Memorandum – Unified Development Review

To: City Plan Commission
From: Brianna L. Valcourt, M.Arch; Senior Planner
Date: August 30, 2024
RE: “Orchard Meadows” – Assessors Plat 28, Lots 31 & 45
Major Subdivision: Preliminary Plan
Application for Dimensional Variance

Applicant: Saccoccia’s Construction & Landscaping
Owner: NKC Investments LLC and Cersosimo Construction LLC
Location: 1489 Pippin Orchard Road
Zoning: A-80 – Single-family dwellings (80,000 sq. ft.)
FLUM Designation: Single Family Residential Less Than 1 Unit Per Acre

OVERALL SITE LAYOUT PLAN
ORCHARD MEADOWS
 ADDRESS: 1489 PIPPIN ORCHARD ROAD, LOT 1, 2, 3, 4, 5
 PREPARED BY: ERIC M. DIPRETE
 DATE: 08/15/2024
 SHEET 4 OF 8

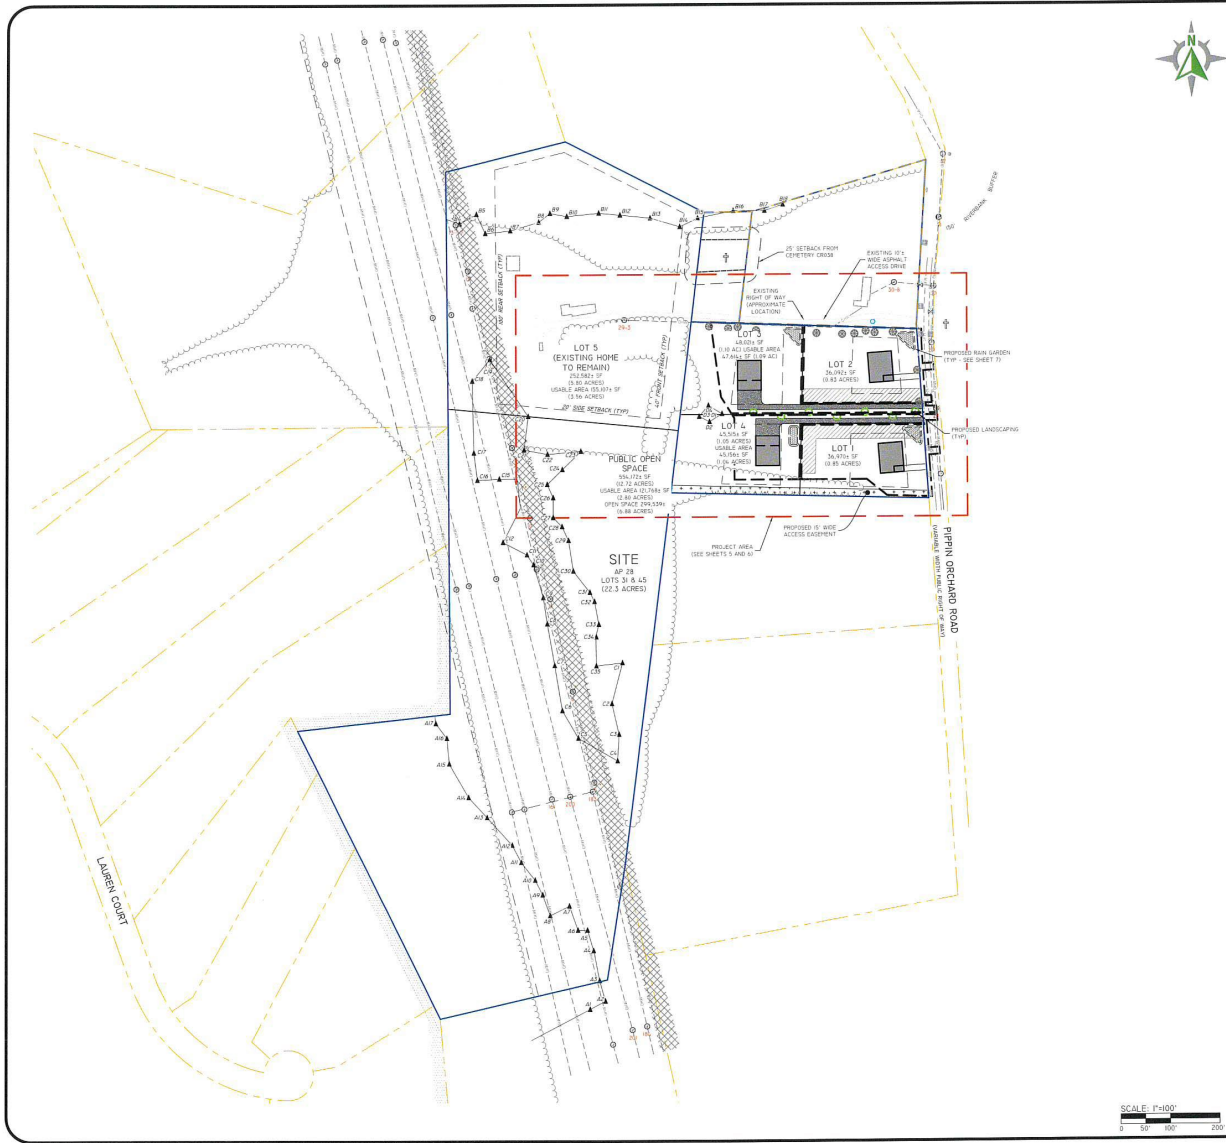
1. Department of Public Works
 - a. Engineering Division: Mr. Justin Mateus, P.E., Public Works Director, has not provided commentary at this time.
 - b. Traffic Safety Division: Mr. Stephen Mulcahy has provided commentary that states Lots 1-4 require a State Physical Alteration Permit (PAP) for new driveway openings.

- c. Sewer Division: Mr. Edward Tally, Environmental Program Manager, reviewed the Proposal and determined that the submission of a sewer design is to be reviewed and approved by the DPW Department and states that a letter from the water authority is still needed at this time.

- d. Providence Water Supply Board: PWSB has not provided commentary at this time. Evidence of a water supply line on the proposed Lots 1-4 is still needed. Staff notes that correspondence will be provided with the Final Plan application regarding suitable supply.

2. Department of Building Inspection & Zoning Enforcement
 - a. Mr. David Rodio, Building Official, has not provided commentary at this time.
 - b. Mr. Stanley Pikul, Alt. Building Official, reviewed the Proposal and determined that the Proposal does require the zoning relief requested. The proposed frontage on Pippin Orchard Road is to be verified and labeled on a plan for each lot, Lots 1-5. Clarification on the use of the 30' utility easements within Lots 1 and 2 is needed at this time.

1. Submission of Municipal Lien Certificates (MLCs) for all applicable lots.
2. Submission of letters of availability from the Providence Water Supply Board for water availability, respectively.
3. Payment of the Eastern Cranston Capital Facilities Development Impact Fee of \$1,389.50 x 5 (\$6,947.50)
